City of Portland Design Commission

Design Advice Request

SUMMARY MEMO

Mailed: July 14, 2021
Date: July 12, 2021
To: Todd Walton and John Fisher, Inland Group
From: Arthur Graves, Design Review
503.865.6517, Arthur.Graves@portlandoregon.gov
Re: EA 21-049773 DA – Burnside Apartments: 10413, 10425, 10439 E Burnside Street
Design Advice Request Memo for July 01, 2021

4. Ground floor activation

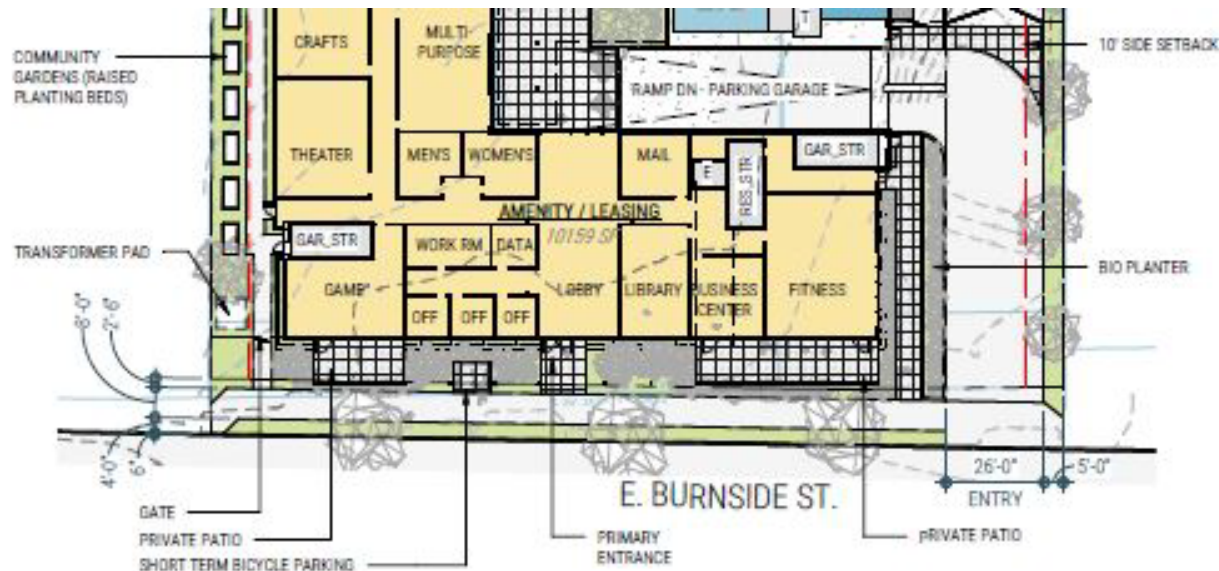
- Ground floor units: Access to the ground floor units is provided internally, should these units also include individual main entrances, stoops, etc.?

4. Ground floor activation

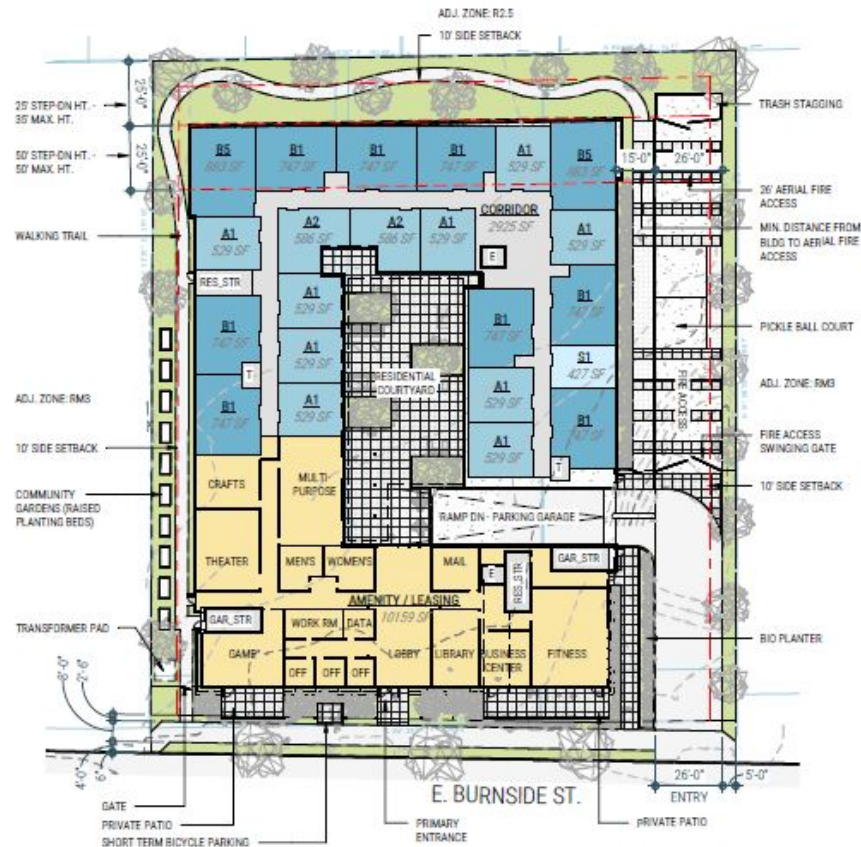
- Outdoor area requirements and interior courtyard: What amenities should be included to ensure this is a successful "recreation and gathering" place that also provides valuable views for the interior facing units?

5. Loading

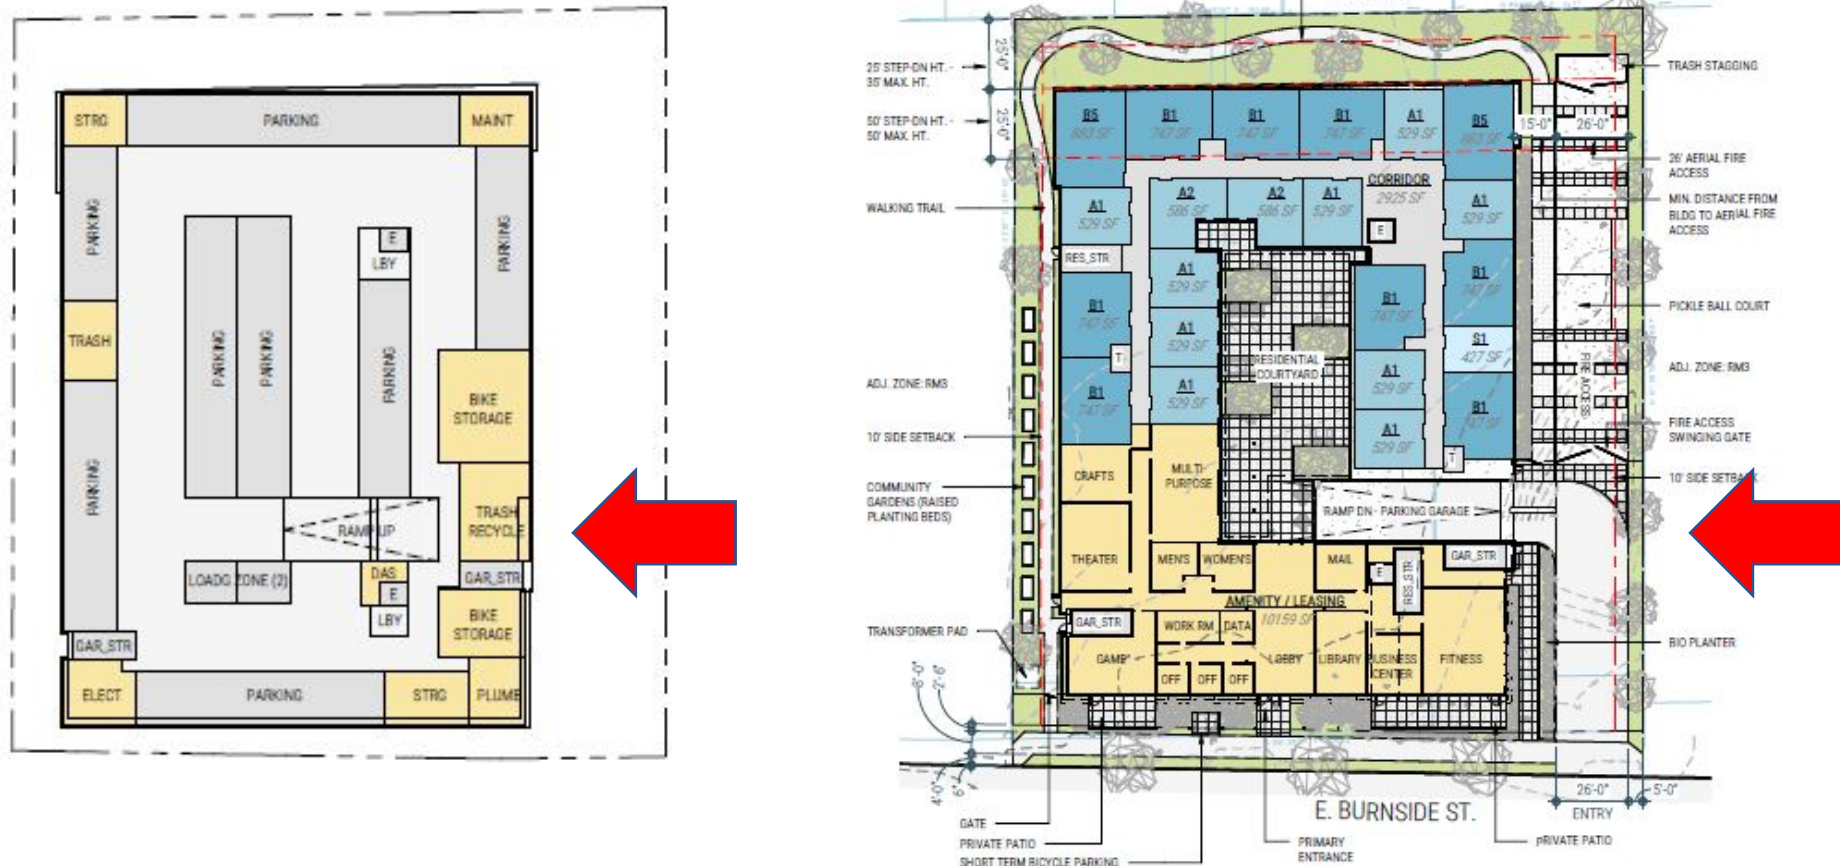
- Exterior vs in below grade parking: In submittals both have been proposed. Locating on the exterior (east side of the building) seems to create awkward conditions and potential conflicts between vehicles and pedestrians.
